PSE&G

# Artificial Island Proposal Window

Questions and Comments for the December 9<sup>th</sup> TEAC

**Figure 1: Hope Creek Switching Station Additional Breaker Expansion. Photo Sourced from Google Earth.**

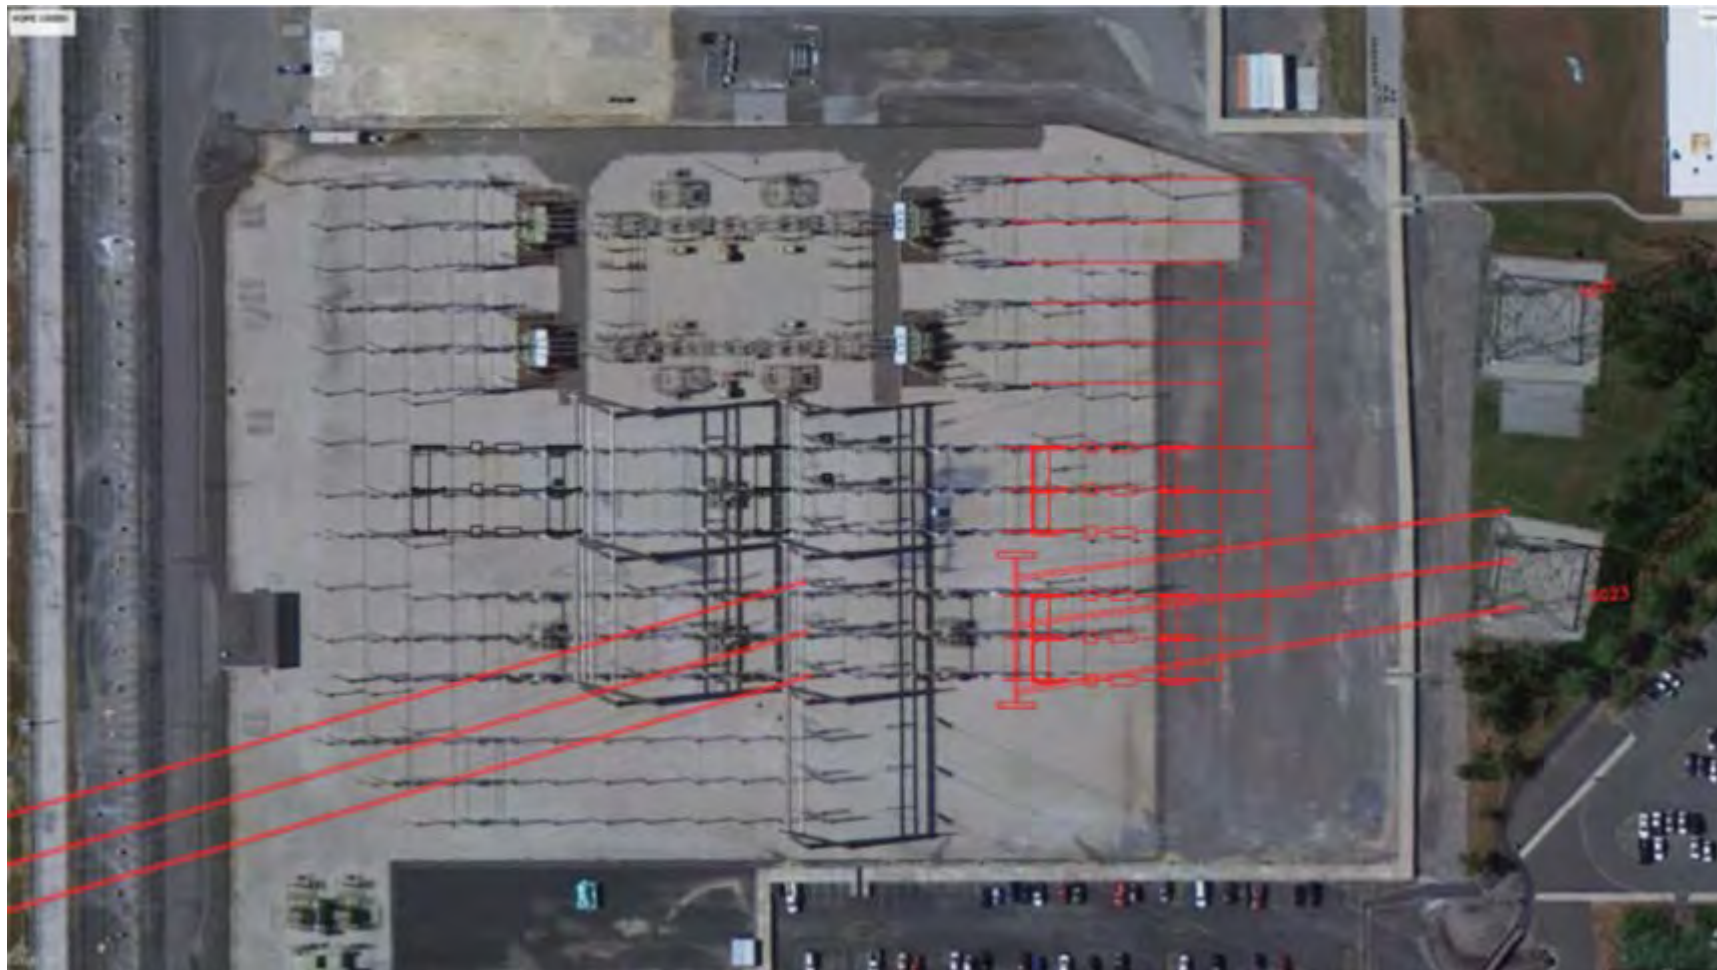
1. Dominion has proposed a single 750 MVAR SVC which could be the largest SVC in the world. Please elaborate on your operational experience in recommending this solution.
2. For reference in Attachment A, two depictions of the requisite expansion of New Freedom and Hope Creek Switching Stations have been provided.
  - a. What basis of design did Dominion use to ascertain that additional 500kv Breakers could be inserted into an existing bay at New Freedom and Hope Creek Switching Stations?

- b. How can the \$17 million that Dominion estimated for these breaker upgrades include the required expansion of both New Freedom and Hope Creek buses to accommodate this equipment and associated relocation of existing circuit terminations?
